**VIRTUAL MEETING OF THE BIRMINGHAM PLANNING BOARD**  
**WEDNESDAY, June 9<sup>th</sup>, 2021**  
**7:30 PM**

**SUBJECT:** 501 S. Eton – Whistle Stop – Special Land Use Permit, Final Site Plan & Design Review

1 ARCHITECTURAL SITE PLAN  
 AS100 SCALE: 1/8" = 1'-0" NORTH

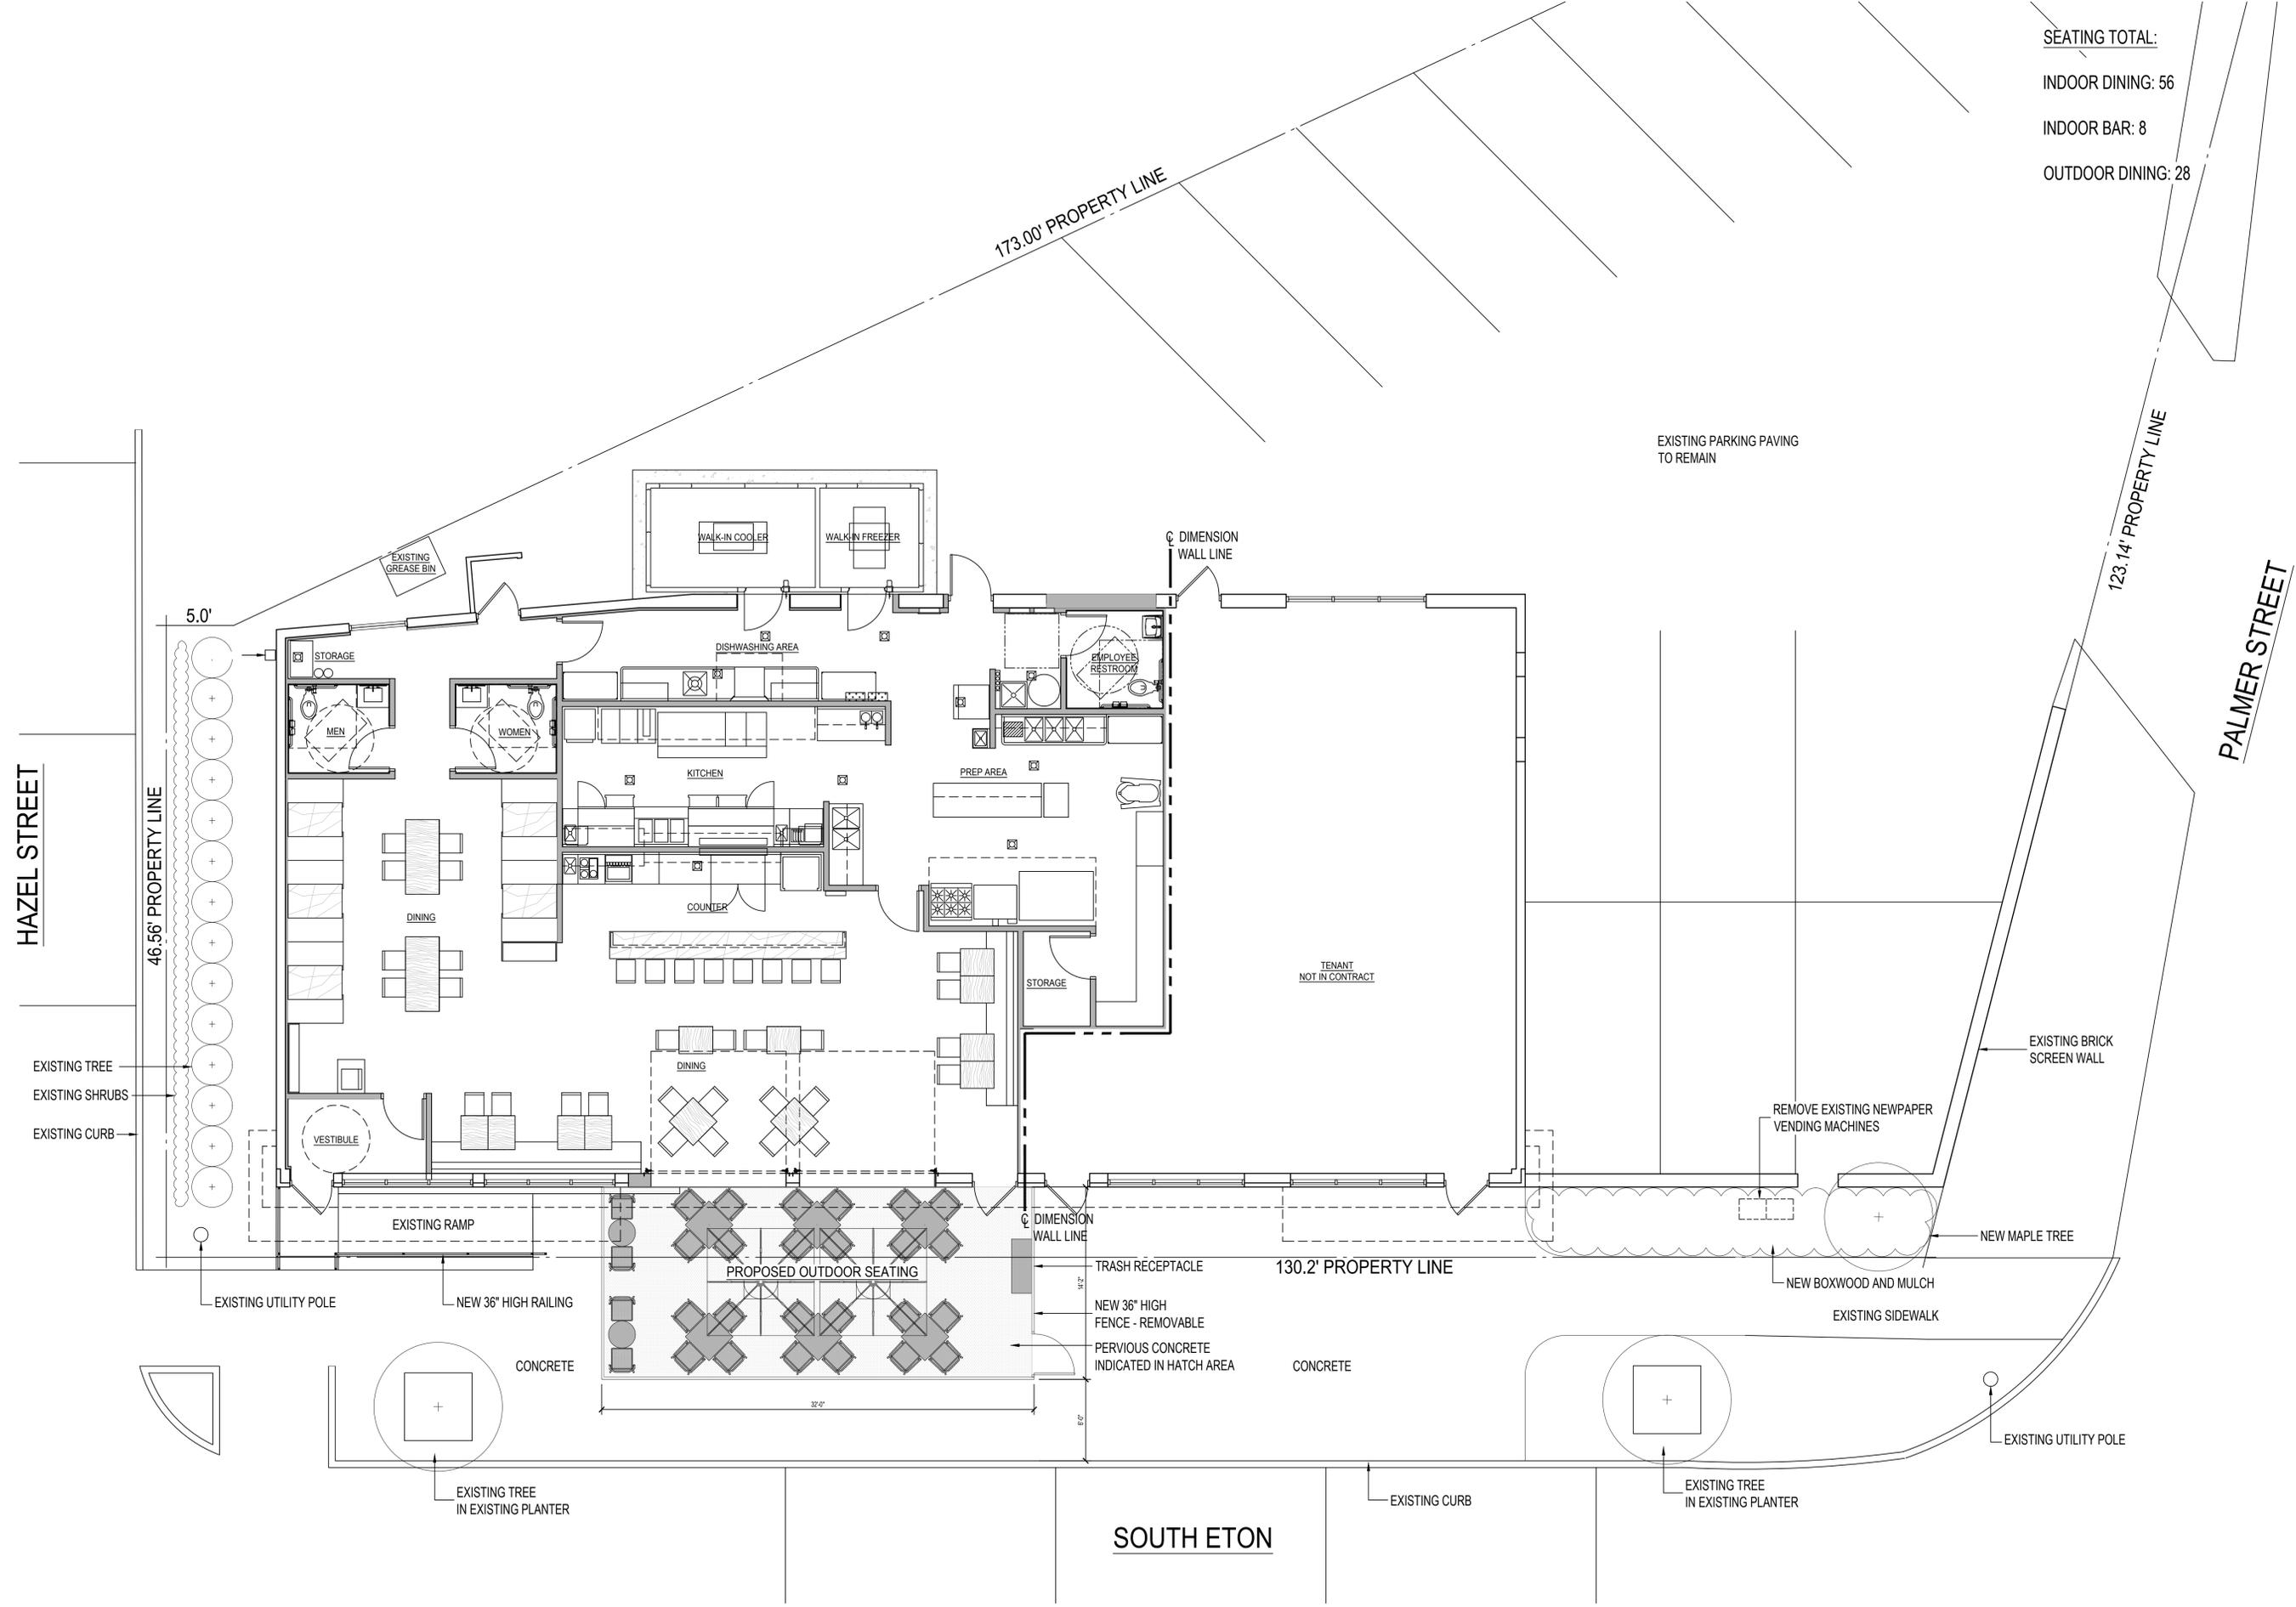
- 4.5 Streetscape – As noted above, the proposed relocation of the outdoor dining area from a platform in the easement to a typical patio adjacent to the building has necessitated a proposed re-design of the streetscape in front of the building. The applicant is proposing to remove 1 of 3 existing street trees and the majority of the grass in the easement to repave and rework the sidewalk around their newly proposed outdoor dining area. The resulting streetscape will contain a small grassy area and tree at the south end of the streetscape, an existing tree in a new planter at the north end, and a 6 ft. clear walking path that curves around the patio to the west.

Article 4, Section 4.20 (G) requires at least 1 street tree for each 40 ft. of frontage. The entire building contains 130 ft. of frontage, which requires 3 street trees. Although the applicant is proposing to remove one of the 3 existing trees, they are proposing to replace the tree at the south end of the property. At this time, however, it is unclear as to whether or not the new tree is proposed on public or private property. Additionally, the spacing of the trees would be mismatched/uneven based on the rest of the S. Eton streetscape. The property line indicated on the site plan submitted extends roughly 5 ft. beyond the face of the building, whereas City records indicate that the S. Eton right-of-way may extend all the way to the face of the building. The Applicant has not yet submitted a Certified Land Survey to confirm the location of the property lines.

- 7.1 Engineering Division – The Engineering Division has provided the following comments:
  - 1. The plans propose to remove at least one street tree, while the other two are noted as “in existing planters,” which do not exist. The current condition has the street trees in grass/mulch.
  - 2. The applicant is proposing to remove a lot of pervious area and the Engineering Division would like to balance that out. The applicant is proposing pervious concrete in the patio space, and we would like to see the drainage plan, as the pervious space would only be as successful as

GLAZING CALCULATION:

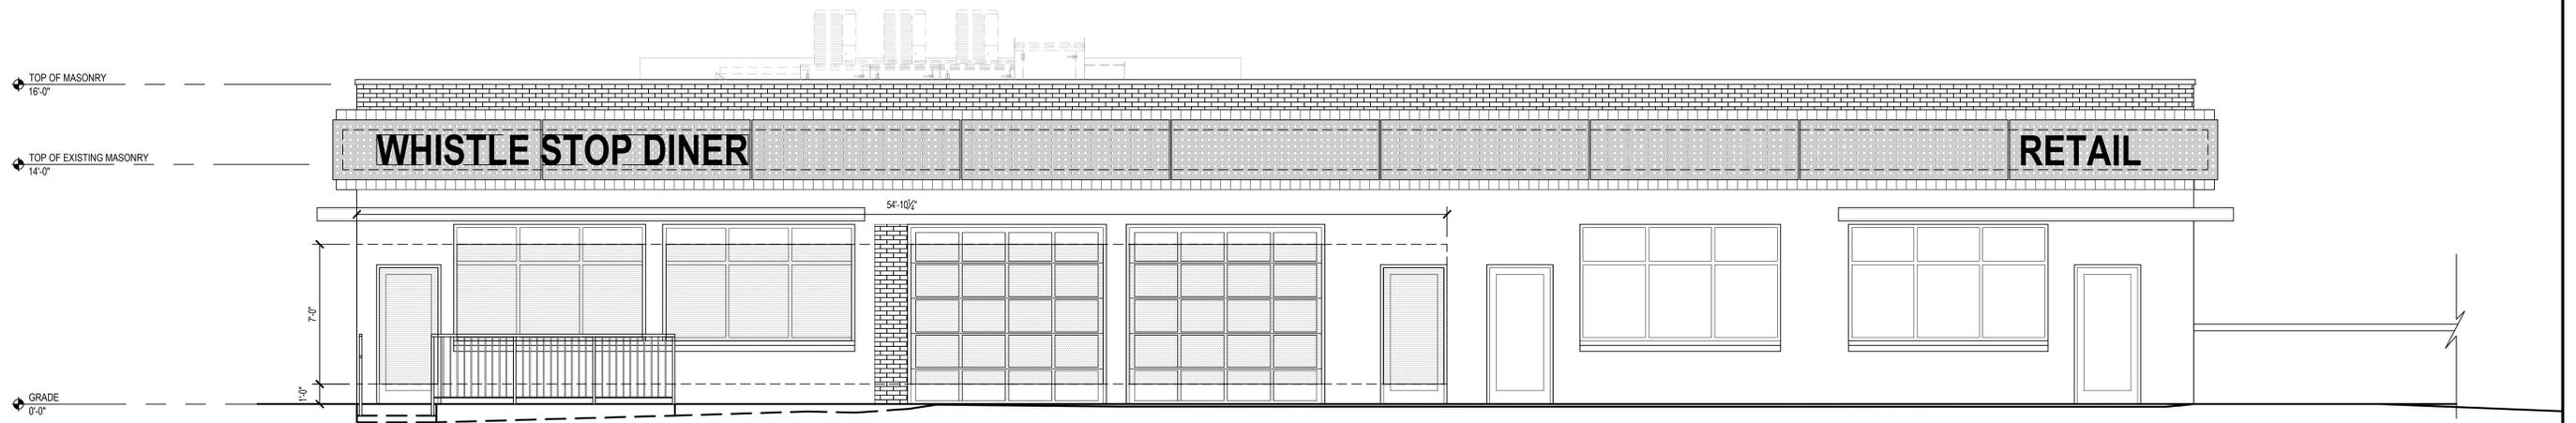
At this time, the applicant appears to meet the above conditions. **Thus, the applicant must receive approval from the Planning Board to provide 67% glazing on the storefront façade, provide additional glazing, or obtain a variance from the Board of Zoning Appeals.**

Furthermore, the applicant has not submitted specification sheets with Visual Light Transmittance (VLT) figures that are required with any new glazing proposed. The new glazing is required to meet the current Window Standards which is 80% VLT. At this time, the Planning Division has been advised that it will be clear and complement the existing glass. The Planning Board may cite the ordinance language above to modify the clarity requirements slightly if the applicant is unable to meet the 80% VLT requirements. Thus, **the applicant must submit specification sheets for the proposed roll down garage doors showing a VLT of 80%, receive approval from the Planning Board for a lower VLT percentage, or obtain a variance from the Board of Zoning Appeals.**

1. The Planning Board APPROVES the proposed 67% glazing on the storefront façade;
